ST. LUCIE PLANT UNIT NO. 1

AMENDMENT TO FACILITY OPERATING LICENSE

Amendment No. 94
License No. DPR-67

ATTACHMENT TO LICENSE AMENDMENT NO. 94

FIGURE 3.1-1 ST.LUCIE 1 MIN BAMT VOLUME

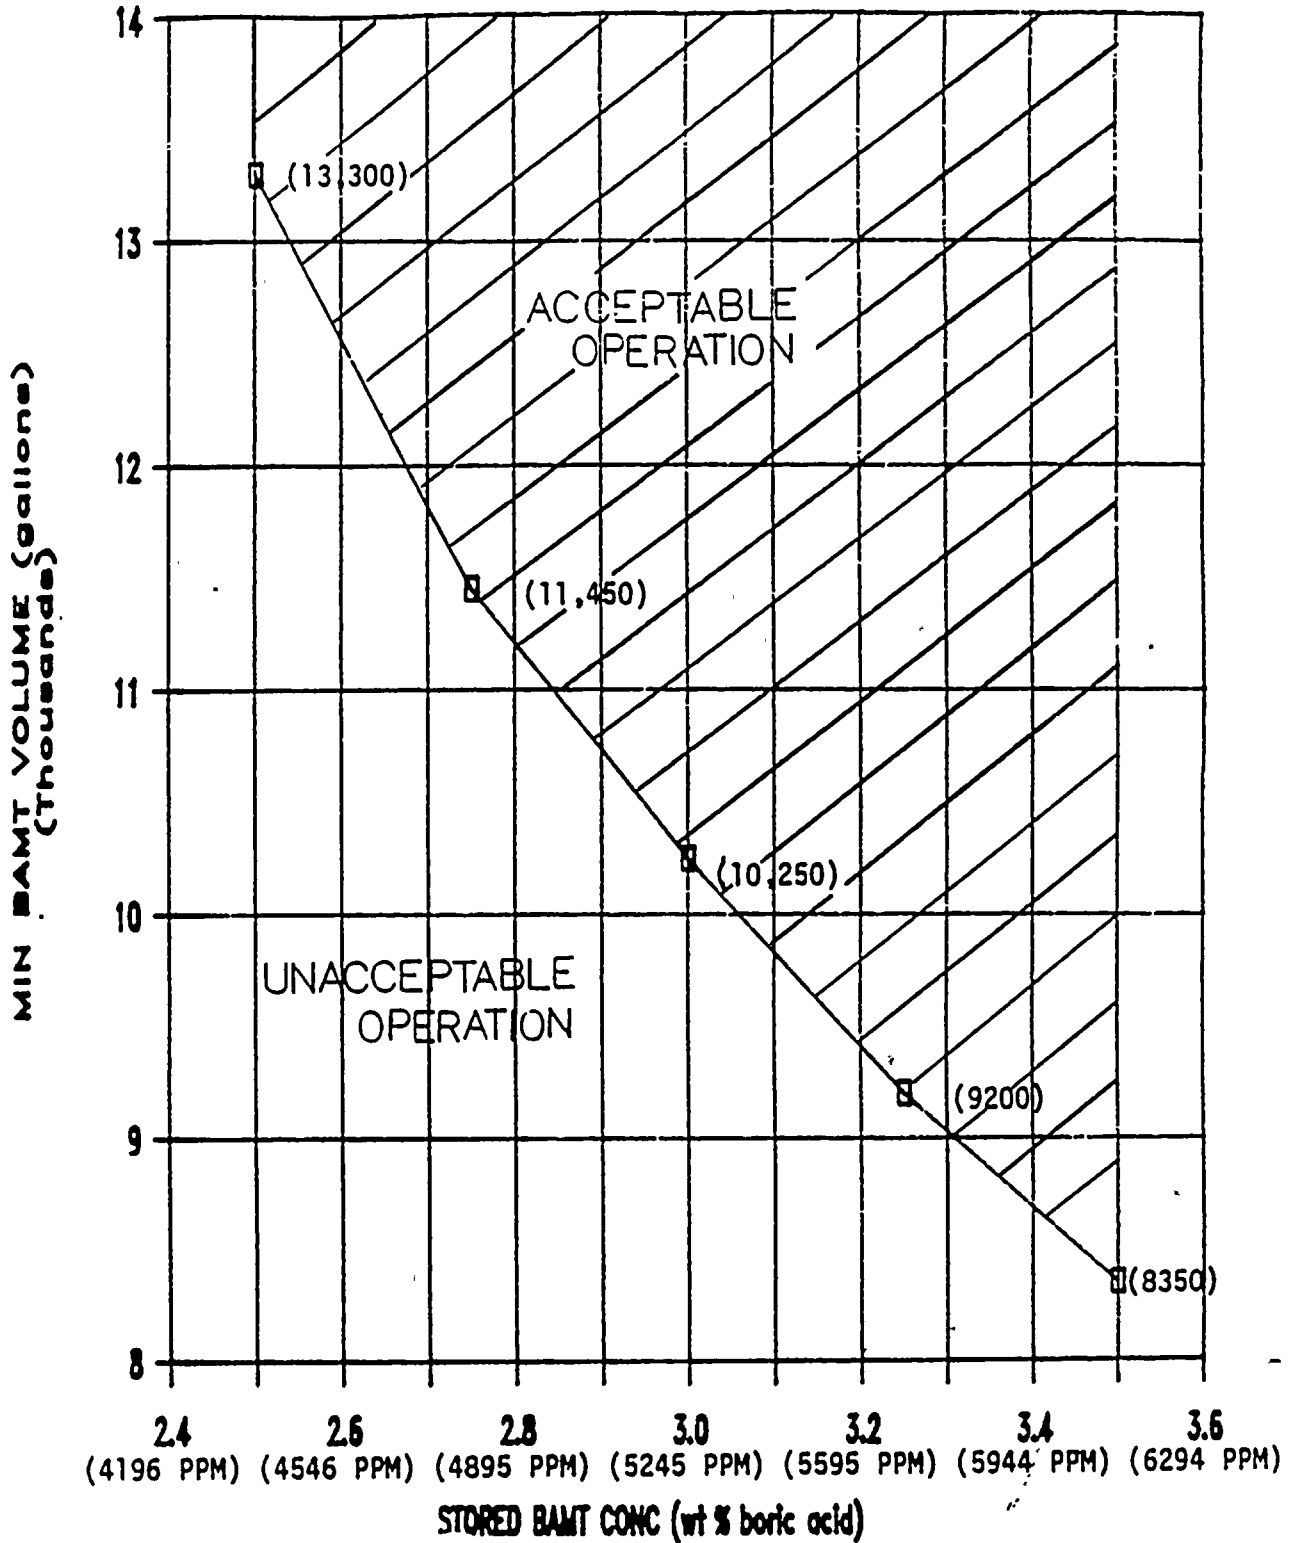
- a. Boric Acid Makeup Tank 1A in accordance with Figure 3.1-1 and in the range of 3.2 to 3.5 weight percent boric acid (5595 to 6119 ppm boron).
- b. Boric Acid Makeup Tank 1B in accordance with Figure 3.1-1 and in the range of 3.2 to 3.5 weight percent boric acid (5595 to 6119 ppm boron).
- c. Boric Acid Makeup Tanks 1A and 1B with a minimum combined contained borated water volume in accordance with Figure 3.1-1.
- d. The refueling water tank with:
 1. A minimum contained volume of 401,800 gallons of water,
 2. A minimum boron concentration of 1720 ppm,
 3. A maximum solution temperature of 100°F,
 4. A minimum solution temperature of 55°F when in MODES 1 and 2, and
 5. A minimum solution temperature of 40°F when in MODES 3 and 4.
